Response to
Request for Additional Information No. 430(4801), DRAFT

Question 10.02-10

U.S. EPR Standard Design Certification

SRP Section: 10.02 - Turbine Generator

Figure 10.02-10-2
Control System Architecture and Interface Chart

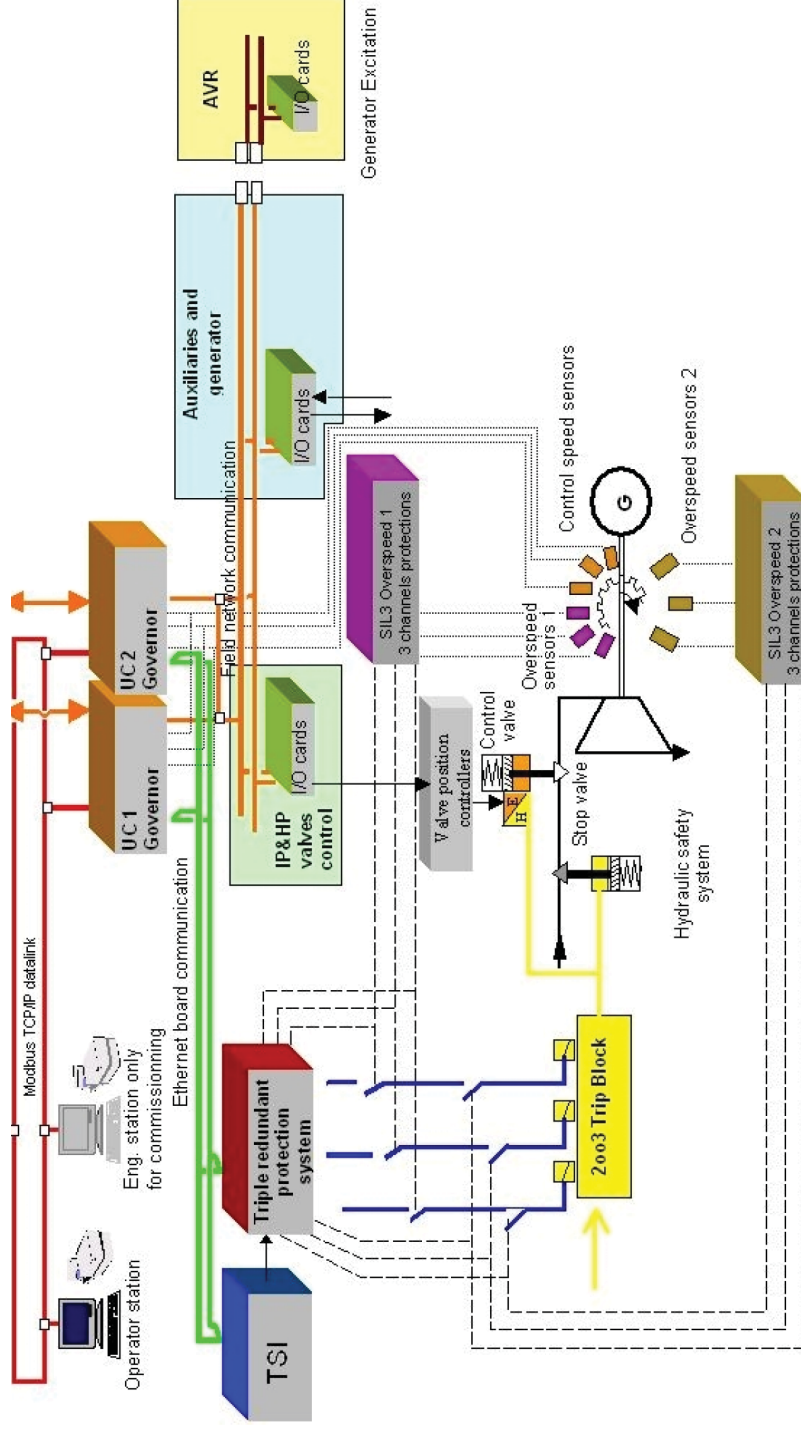
- 4) The response to RAI 10.2-6 indicates that the normal turbine generator speed control governor is independent of the turbine overspeed protection systems, but the design is not adequately described in the FSAR. The FSAR needs to include a description of the normal speed control system for the turbine generator, including major components that are included in the design and the system functioning and interfacing with other systems to prevent a turbine trip following a load rejection during full power operation.

The architecture of the control system is shown in Figure 10.02-10-2. There are two sets of three overspeed protection sensors, one set of three control speed sensors, and one spare speed sensor which is not shown. The two sets of overspeed protection sensors are connected to two separate electronic overspeed protection systems, with no common or shared components and powered by two separate power sources. Each overspeed protection system processes the sensors analog signals in three logic signals for the command of three relays on the three trip channels. These three logic signals are also sent to the triple redundant protection system, which will also order a TT in case of a turbine overspeed.

The three control speed sensors are independent of the overspeed protection systems. The analog signals from these sensors are sent to the two redundant speed governors, located in the turbine generator controls cubicle, and processed to give main steam and reheat control valve position commands. The two-speed governors provide on-line redundancy in a hot standby arrangement.

The redundancy of the speed governors allow for safe valve control. If one speed governor fails, the second speed governor still measures speed and controls the valve position. If both speed governors fail, the triple redundant protection system will order a TT, providing an overall control system that is fail-safe.

Figure 10.02-10-3
Turbine Trip Block Schematic

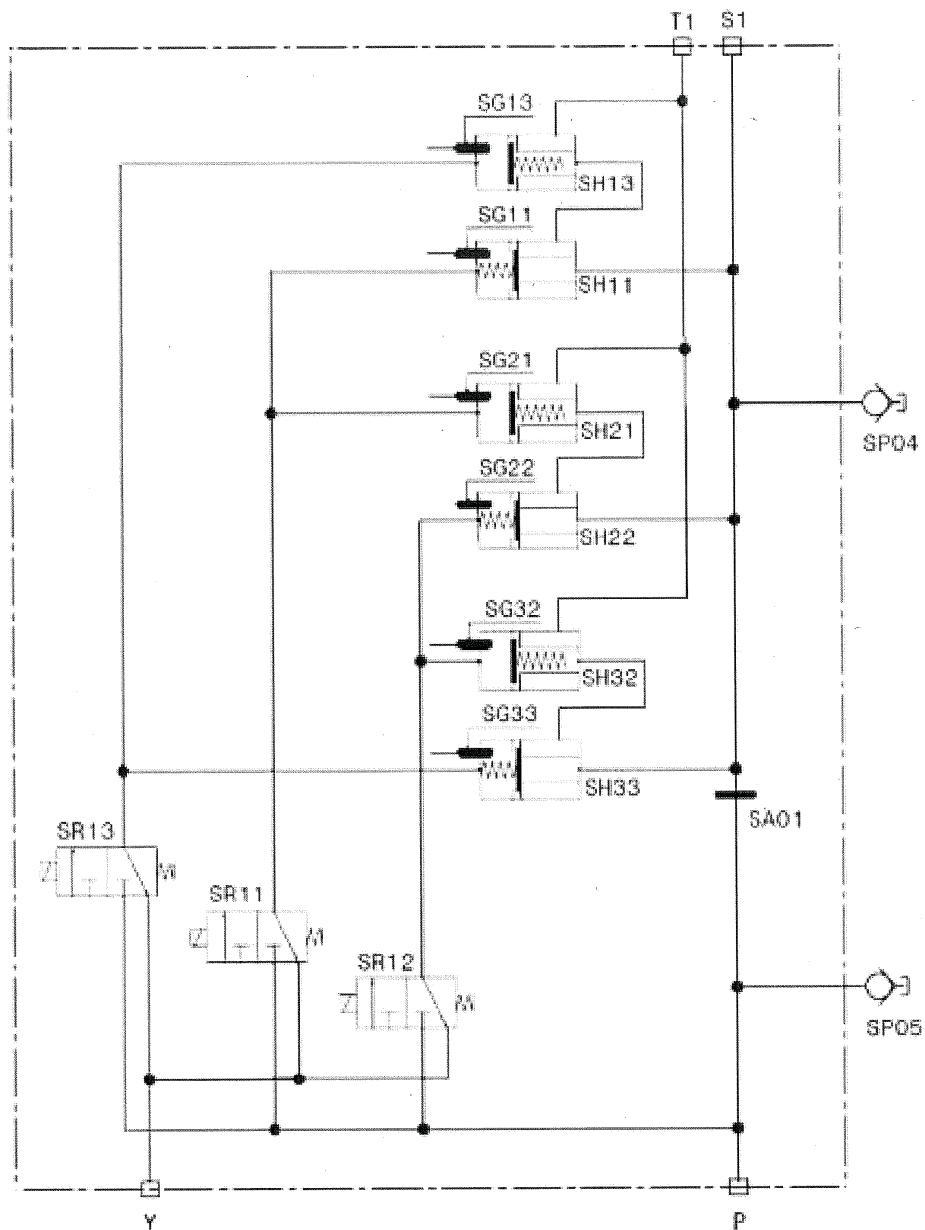
- 6) The response to RAI 10.2-7 included Tier 2 Figures 10.2-2 and 10.2-3 in proposed FSAR markups. However, these figures are incomplete in that they don't indicate if they represent the tripped configuration or the normal operating configuration, and the designations of "E" and "S" on Figure 10.2-3 are not defined. Also, the hydraulic interface with the trip block seems to be a single flow path in some areas which does not satisfy design considerations with respect to independence and redundancy, and small hydraulic flow passages could be subject to flow blockage. Furthermore, the response to RAI 10.2-6 indicates that the trip block dumps hydraulic fluid to a hydraulic tank which causes a low pressure signal to be sent to a safety relay for each turbine steam admission valve actuator. These safety relays cause hydraulic fluid to be dumped from the valve actuators for the turbine steam admission valves resulting in valve closure. From the figure and related description in the FSAR, it is not clear that this is accomplished and in particular, that independence and redundancy is provided by the design in this regard. The FSAR and figures need to be revised to provide a more clear description. Similarly, this sort of information needs to be provided for the extraction steam NRVs that are relied on for preventing turbine overspeed.

Figure 10.02-10-3 and U.S. EPR FSAR Tier 2, Figure 10.2-3 both show a “tripped condition.” Normal operation is with all the switches in the closed position. In Figure 10.2-3, “E” represents inlet and “S” represents outlet.

Figure 10.02-10-3 shows a more detailed schematic of the trip block. In U.S. EPR FSAR, Revision 3, U.S. EPR FSAR Tier 2, Figure 10.2-3 was replaced by Figure 10.02-10-3 shown in this response. The solenoid valves are shown in the tripped condition and the plate valves are shown in the normal operating condition. The connection letters in the figure represent the following:

As shown in Figure 10.02-10-3, there are three separate flow channels between the solenoid valves and plate valves. There is a common inlet header and common outlet header. See the Response to Question 10.02-9, Item (1) and Item (4). The design of the control fluid system with respect to materials of construction, fluid filters and fluid conditioning will minimize any plugging of the system flow channels. The solenoid valves and plate valves are tested daily, which also provides an indication of problems with the valves or plugging of the flow channels.
